PSI DWG # V049-8-496

ITEM	QTY.	PART NO.	DESCRIPTION	PLT, .50 THK, 2.8 X 4.3
PART LIST			MATERIAL SPECIFICATION	304 SST
UNLESS OTHERWISE SPECIFIED		CONTRACT OR SALES ORDER NO.		GNB Corporation SCIENTIFIC AND INDUSTRIAL EQUIPMENT 30971 San Benito Court HAYWARD, CALIFORNIA 94544 (510) 441-1900 FAX: (510) 441-0939
DIMENSIONS ARE IN INCHES TOLERANCES ARE: DECIMALS ANGLES FINISH .01 ± .10' 125 ✓ JOK ± .005 UNPROCESSED FILLETS R.015 BREAK EDGES .010 ± .45V REMOVE ALL BURRS		APPRX. WT.	2.5#	
THIRD ANGLE PROJECTION		APPROVALS		TITLE
		DRAFTER CHECKER		MOTOR MOUNTING STIFF. G44E, G48E
C103315	DO NOT SCALE DRAWING	ENGINEER	ZH	2-14-96
USED ON	CADD FILE NAME	A103313C		DWG. NO. 103313 SCALE: NONE SHEET 1 OF 1

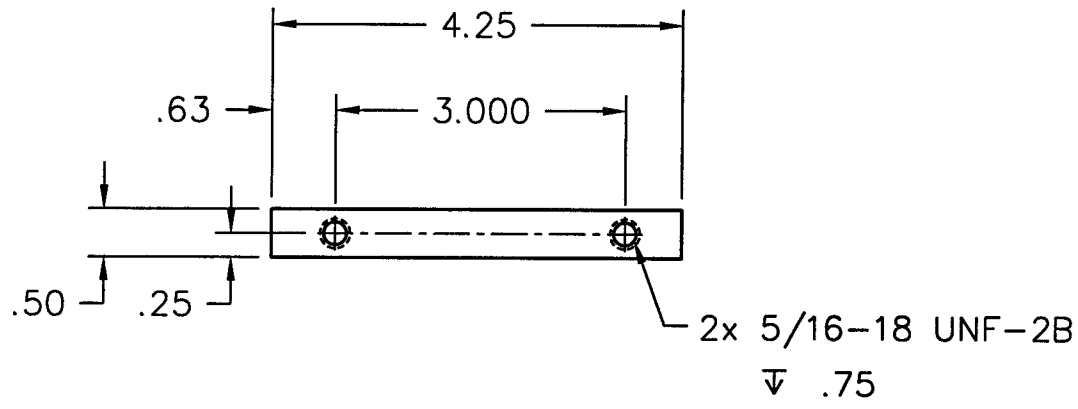
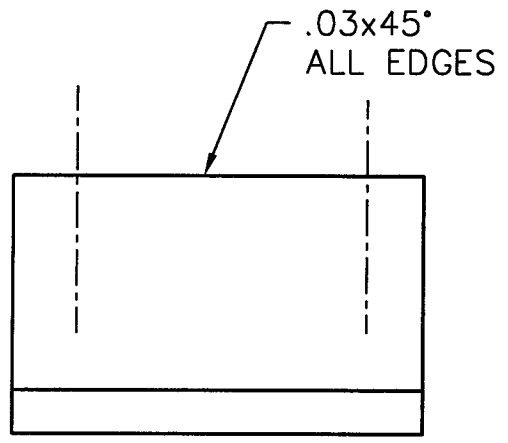
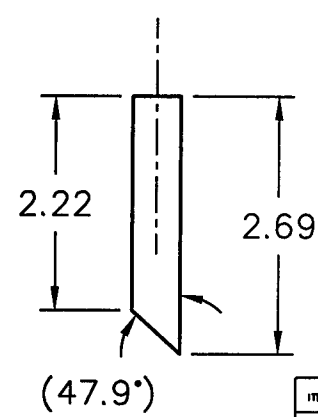
REV.	DESCRIPTION	APPROVED	DATE
B	RELEASED		
C	2.22 WAS 3.22; 2.69 WAS 3.69; REDRAWN	AJL	10/9/96
